Side Load Garage

Lot 125 - Duncan's Creek

245 Duncan Creek Road  
Lillington, NC 27546

# THE APEX - LH 'TRADITIONAL'

**SECOND FLOOR PLAN 'TRADITIONAL'**  
SCALE: 1/8"=1'-0" ON 11x17, 1/4"=1'-0" ON 22x34

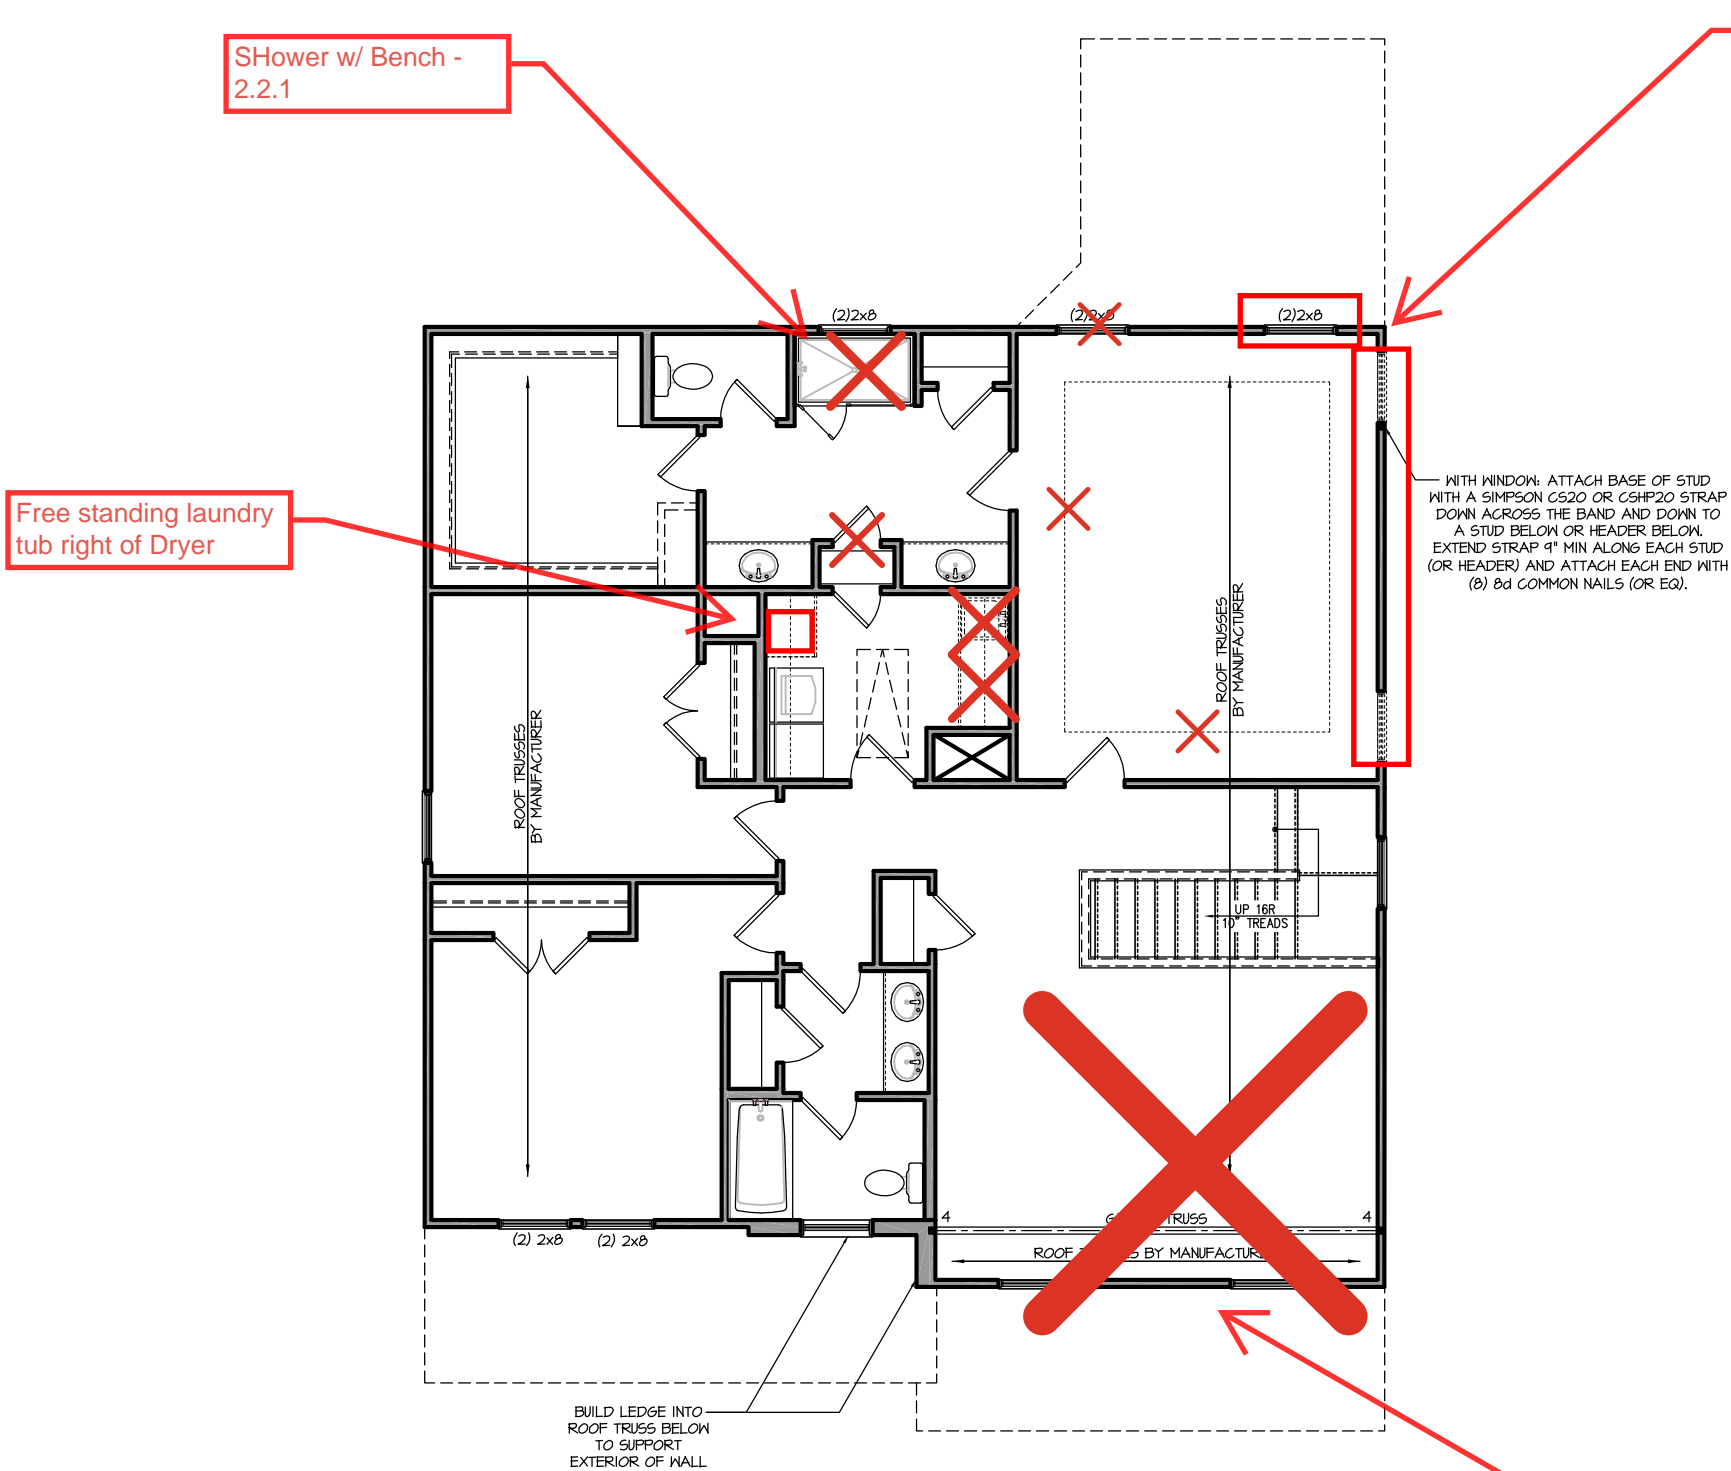
Extended Game  
Room - Room  
dimension changes -  
S-2.2.1
